PLANNING COMMISSION REGULAR MEETING AGENDA

Wednesday, August 27, 2025
7 p.m.

7. **PUD-152, 231 Old Bernal Avenue Workshop** - Workshop to review and receive comments on a Planned Unit Development application to demolish an existing approximately 6,160-square-foot commercial office building and construct a three-story building consisting of an approximately 15,008-square-foot single-family residence with an approximately 725-square-foot ground-floor live-work space with associated site improvements located at 231 Old Bernal Avenue
8. 2025-2026 Planning Commission Work Plan and Community and Economic Development Department Priorities

Figure 6: Front Concrete Wall and Gate

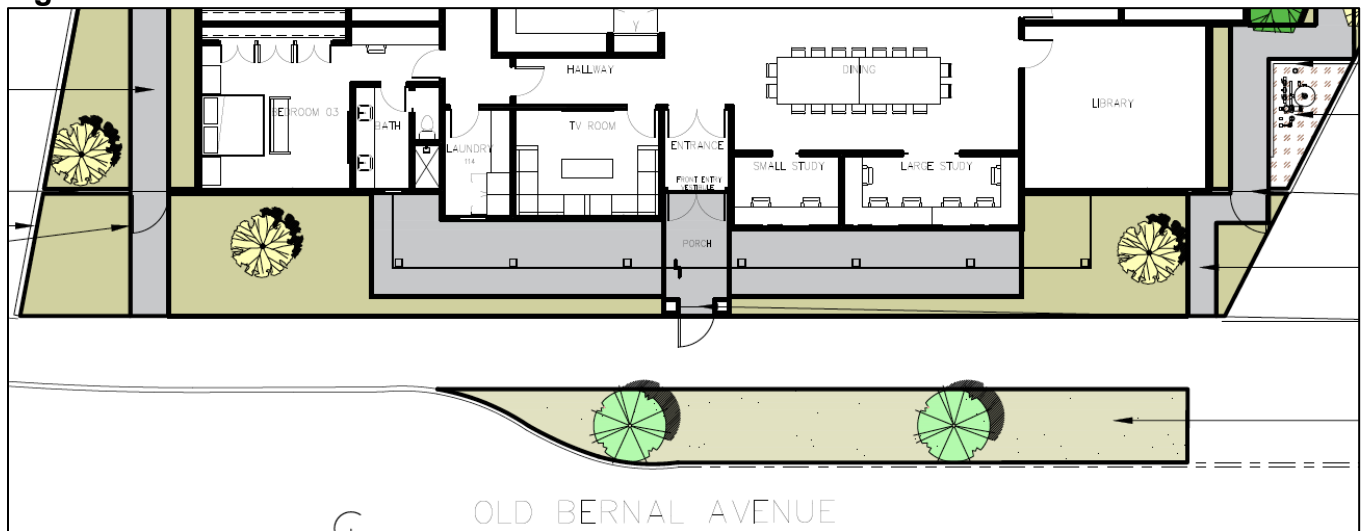
As proposed, the applicant is proposing an approximately 5-foot-wide front yard setback, with an approximately 5-foot-tall concrete wall at the back of the sidewalk along Old Bernal Avenue, with an outward swinging gate (Figure 6). Although landscaping is proposed on the concrete wall, the building does not include landscaping features such as flowering vines on trellises or arcades, flowerpots and window boxes (DSP Policies LD-P.14, LD-P.21, and LD-P.51). Furthermore, the proposed enclosed entry limits visibility and accessibility of the main entrance from the Old Bernal Avenue street frontage (DSP Policy LD-P21). Lastly, staff is concerned

The proposal does not currently include a streetscape to illustrate the street-level transition; however, it's estimated that wall-to-wall building separation from the proposed building to the existing structure to the west is approximately 24 feet, which is slightly less than the existing approximately 25-foot separation. See Sheet C2.0 of Exhibit B for an illustration of the existing building separation, and Sheet C1.0 of Exhibit B for the proposed building separation.

Staff finds the residential building and site design should be modified to provide more consistency with the DSP Land Use and Design Goals and the ODS. To achieve this, staff recommends the building maintain a minimum 10-foot front yard setback as prescribed in the ODS A1.A.1(b) and the building orientation be so that frontages are activated with entries, storefronts, and living spaces along streets, pedestrian paseos, and common open spaces, to provide activity, safety and security through informal surveillance (ODS B2). Also, staff advises that the front yard concrete wall (including the gate) be removed or modified with a height that would not screen or obscure the main entrance visibility and accessibility. Furthermore, in replacement of the front yard concrete wall, the front façade should be enhanced by including pedestrian elements, such as flowering vines on trellises or arcades, flowerpots and window boxes (LD-P.14, LD-P.51).
